**ENGINEERING REVIEW COMMENTS IN
BLUE BOXES WITH BLUE TEXT**

**Eastonville Road – Londonderry Drive to Rex Road
Segment 1 Improvements
Stationing 14+55.00 – 47+00.00**

Final Drainage Report

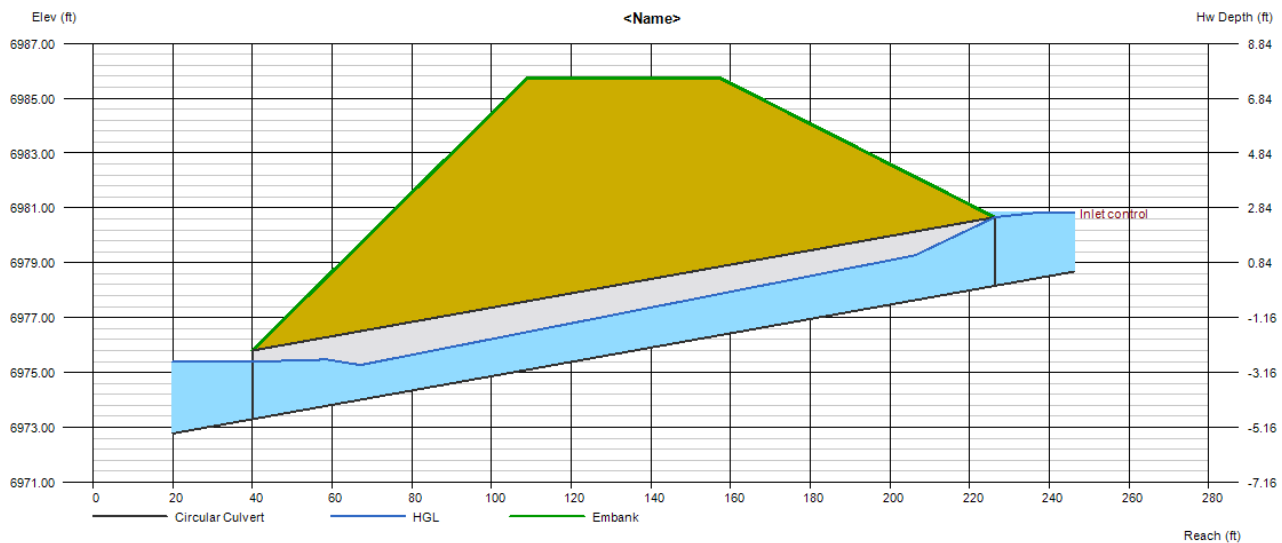
Provide calculations for riprap outlet protection & all other pipe outlet locations.

EASTONVILLE 1 - OUTLET - 100-YR TAILWATER CONDITION

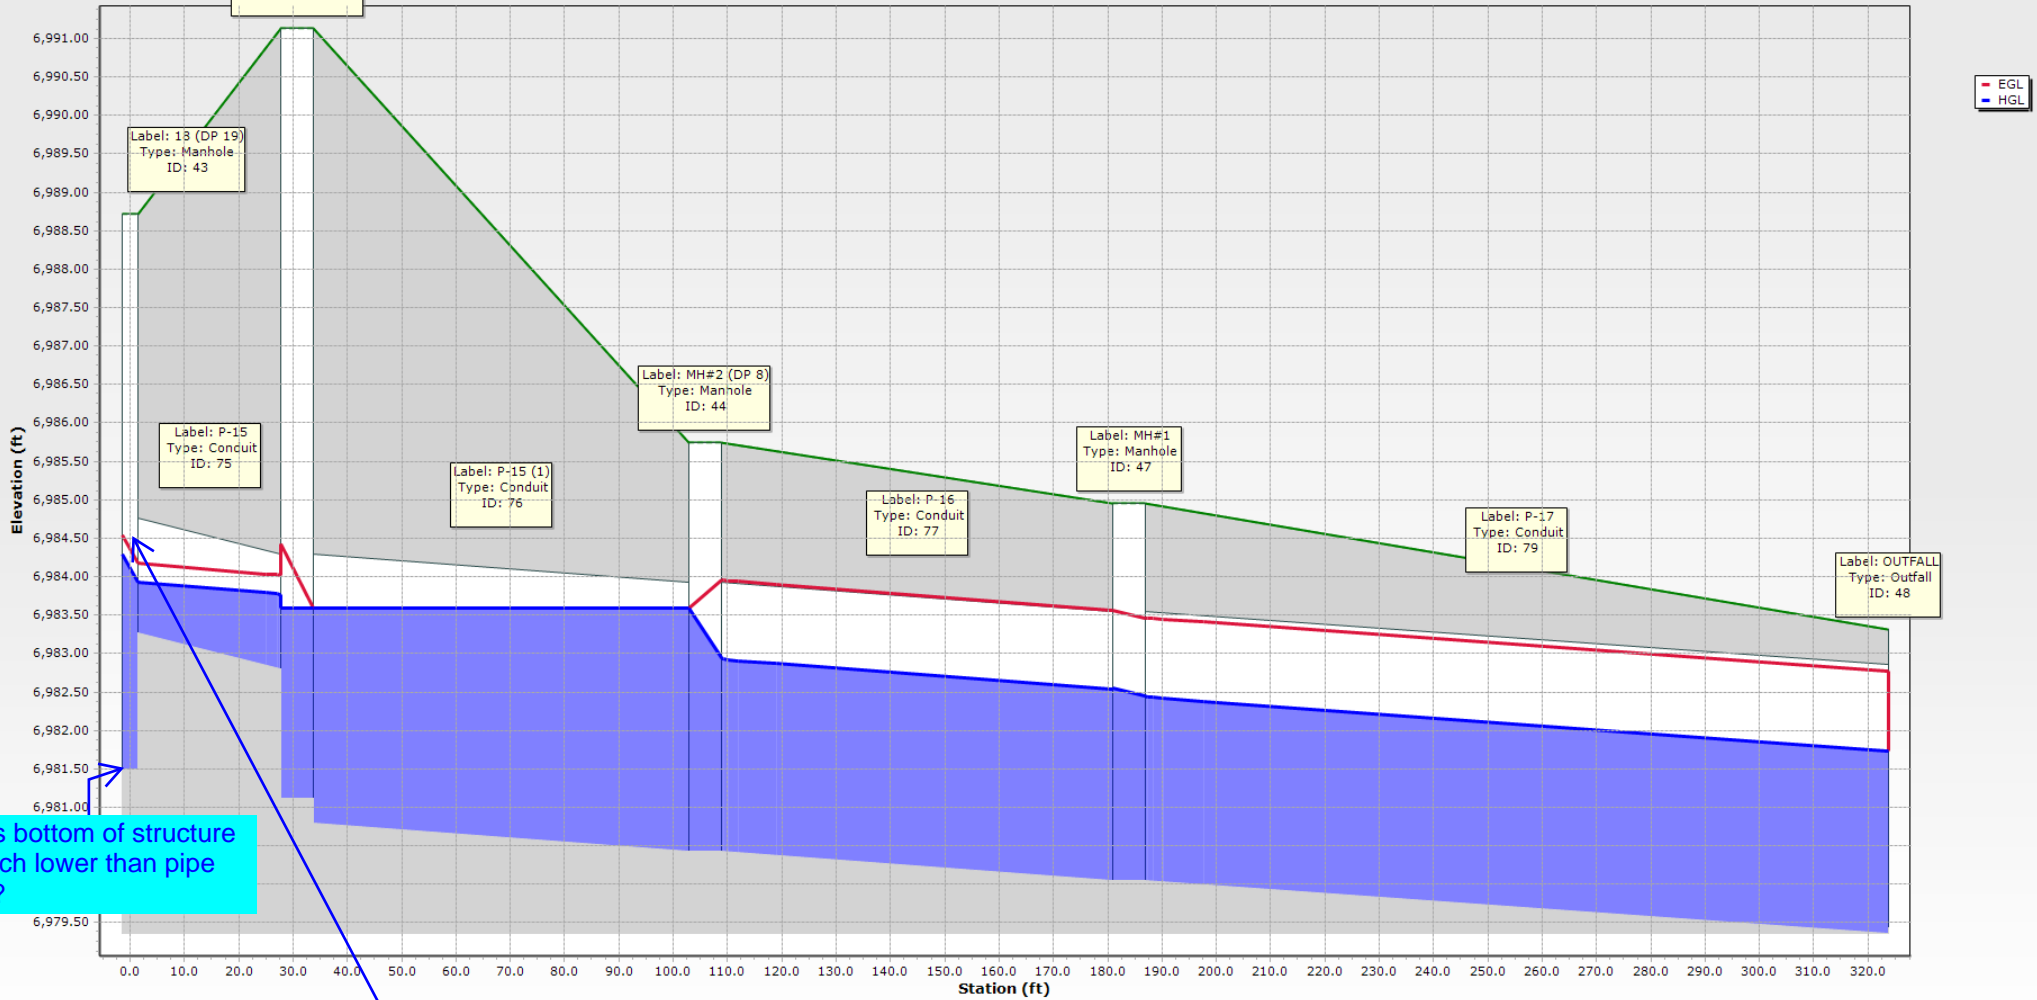
Why is bottom of structure much lower than pipe invert?

System design needs to start with 100-year water surface elevation in the pond

EASTONVILLE 17 - 100-YR TAILWATER CONDITION - Time: 0.00

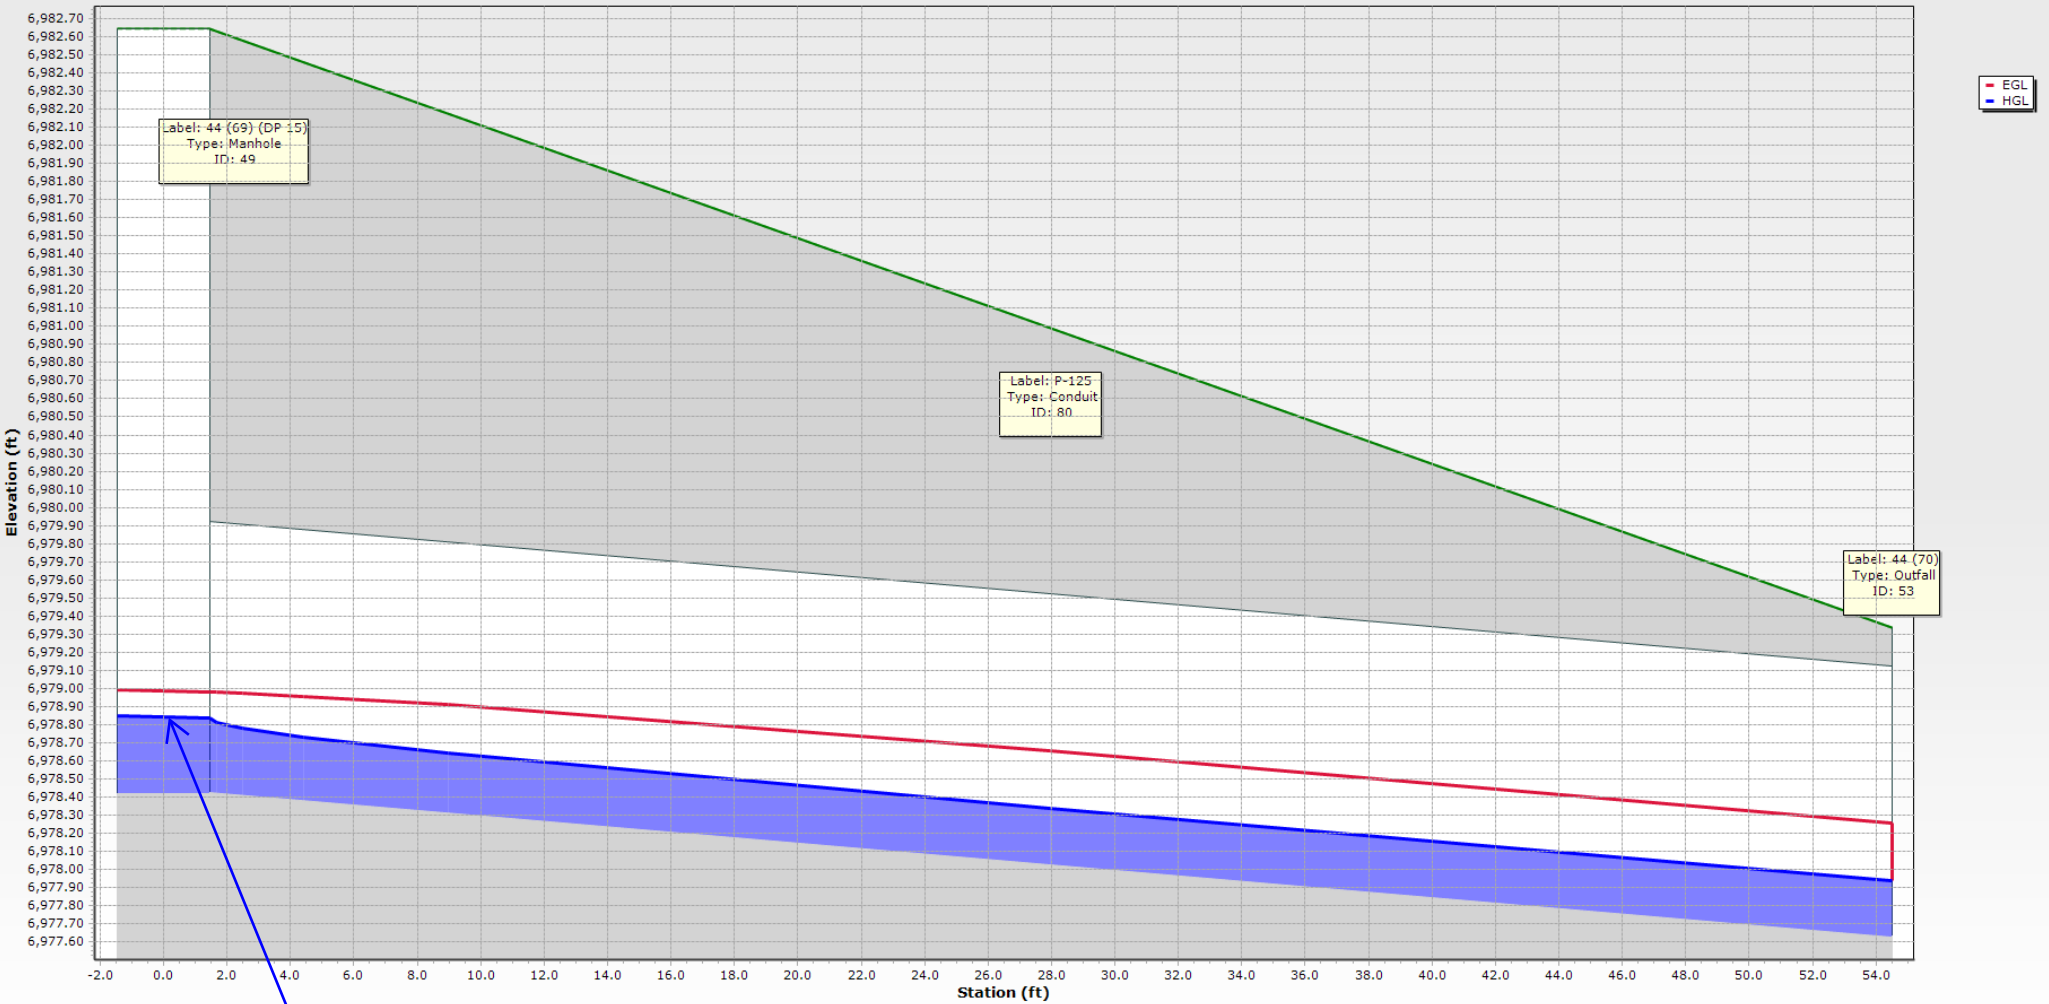
System design needs to start with 100-year water surface elevation in the pond

EASTONVILLE 4 - 100-YR TAILWATER CONDITION

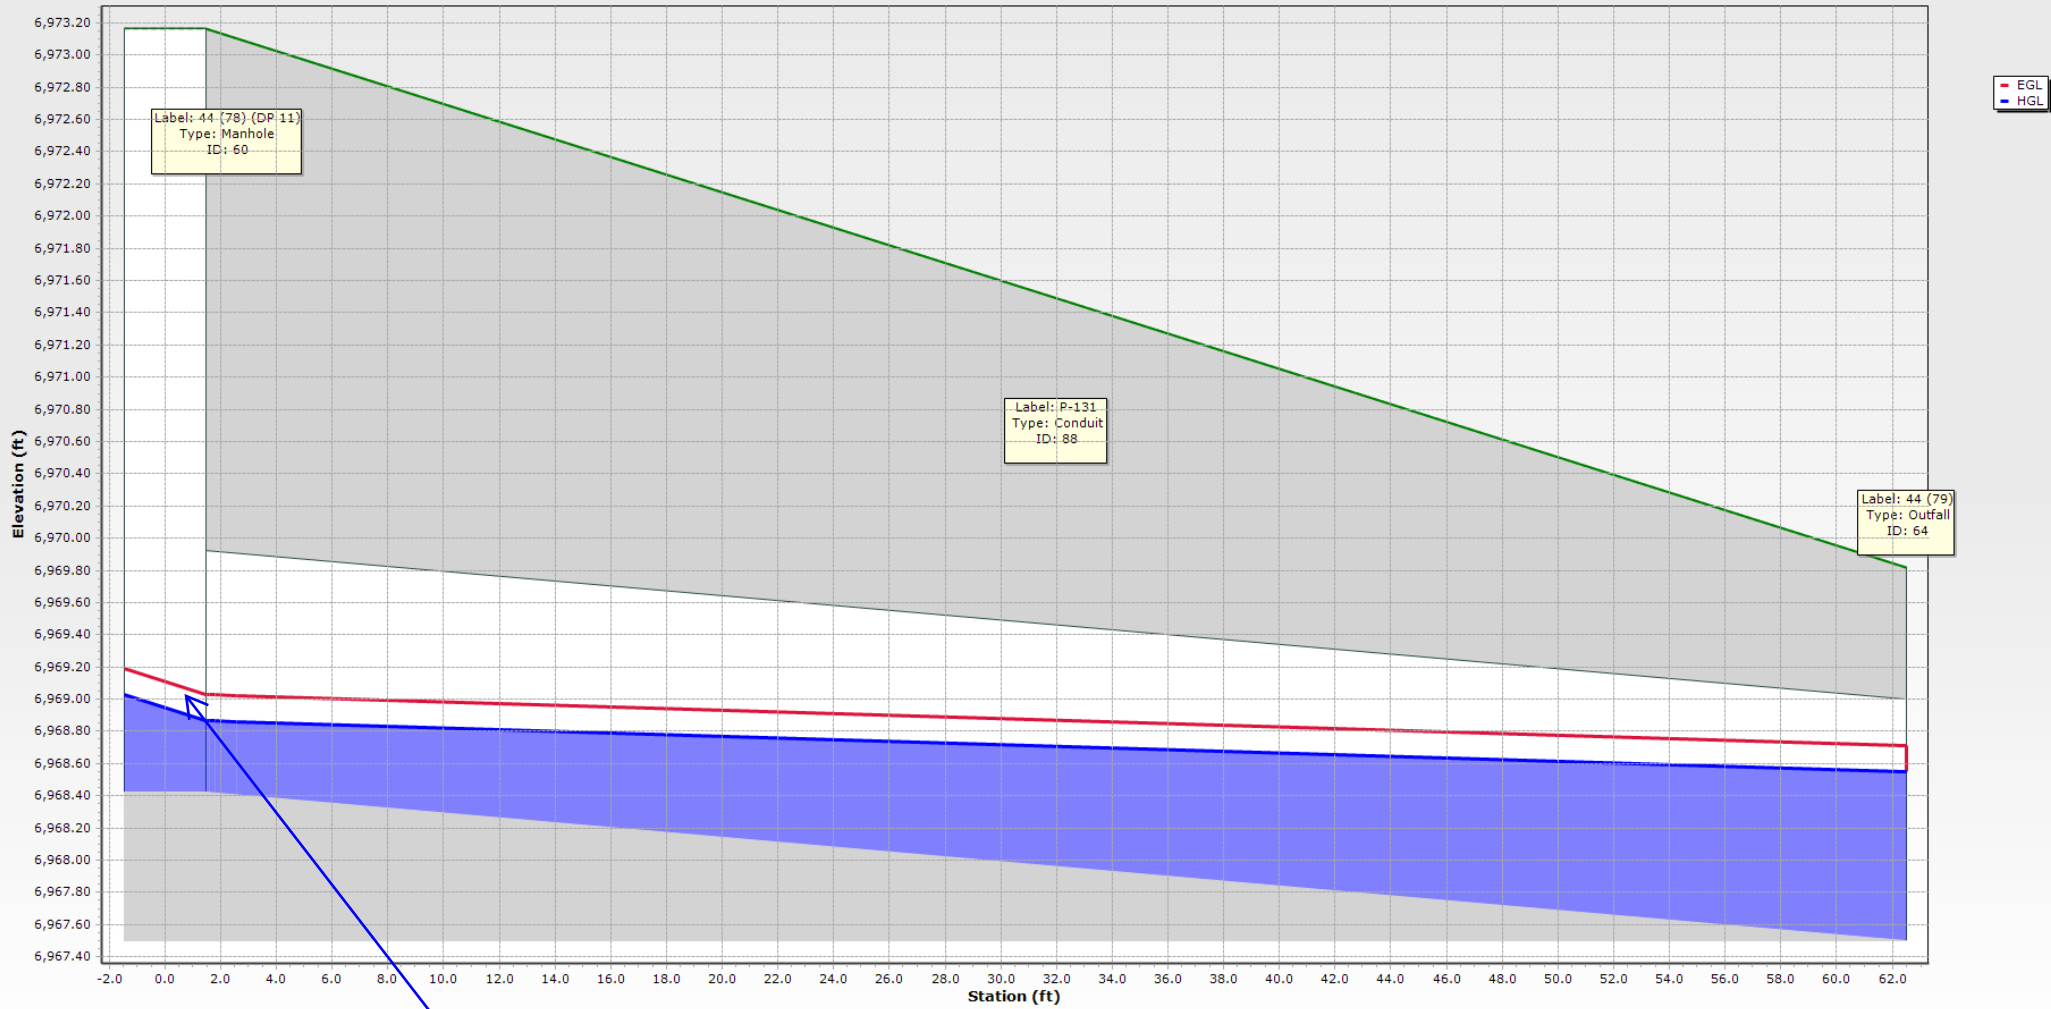
System design needs to start with 100-year water surface elevation in the pond

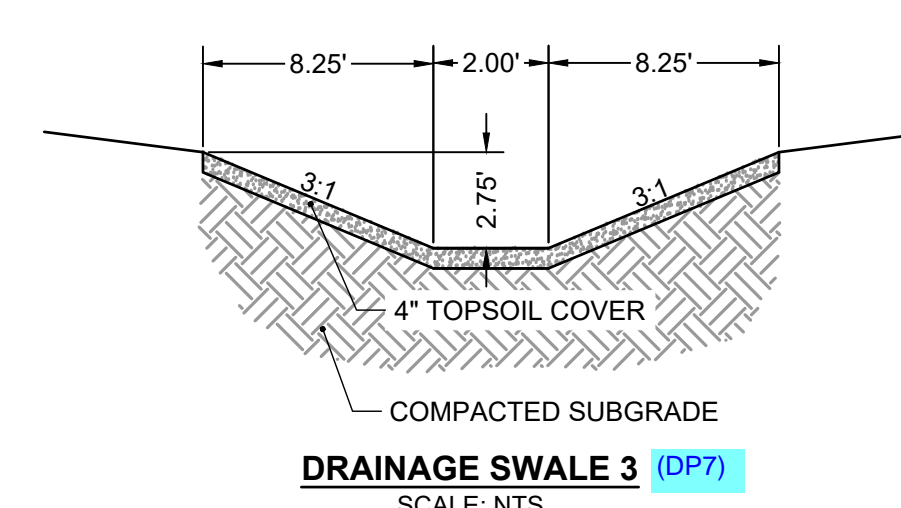
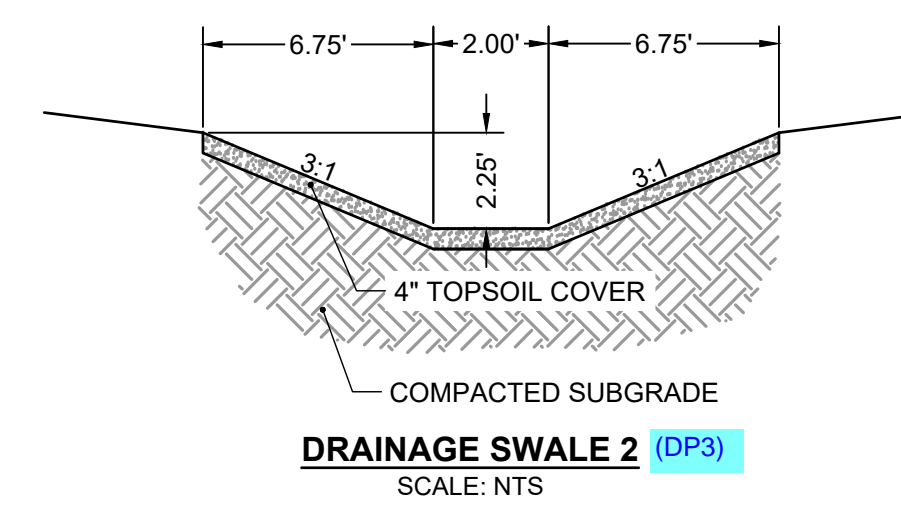
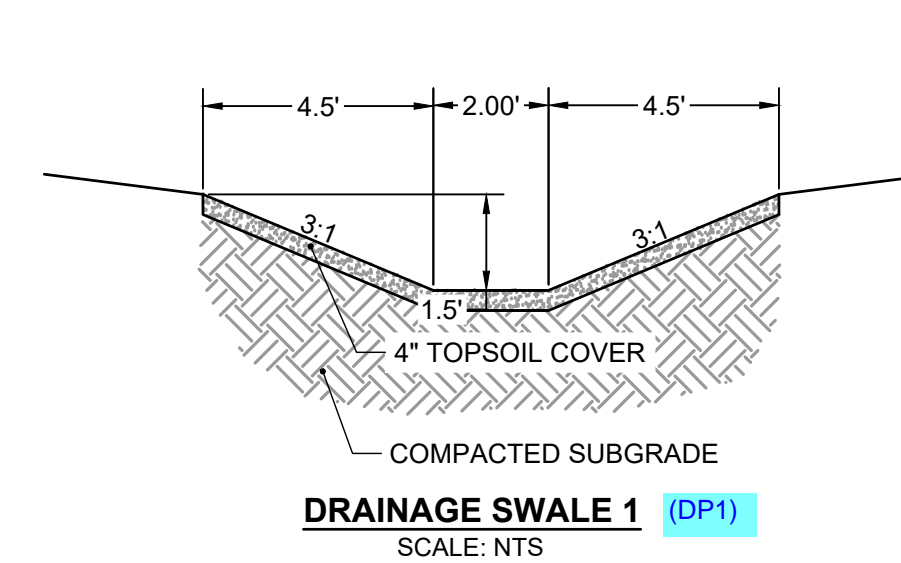
Unresolved comment from Review 1: All areas of disturbance must be accounted for via WQ treatment or an applicable WQ exclusion. A table would help organize and summarize how all disturbances are accounted for. Two example tables have been provided.

Review 2 update: in the report text above you just added in that these glass swales will get WQ via infiltration. This statement has to be supported with calcs.

Provide analysis check of existing channel to show if any additional stabilization is needed and it's an adequate size to convey proposed flow

Provide calculations for all riprap outlet protection (size, length, width)

Provide flow arrows to indicate combined flows at DP2 and downstream flow direction. Add another design point for combined flows if needed (DP2, EA13, pond outflows)

Provide calculation for type 13 inlet

Show and label existing 36" CMP and whether it remains or removed (replaced at DP1?)
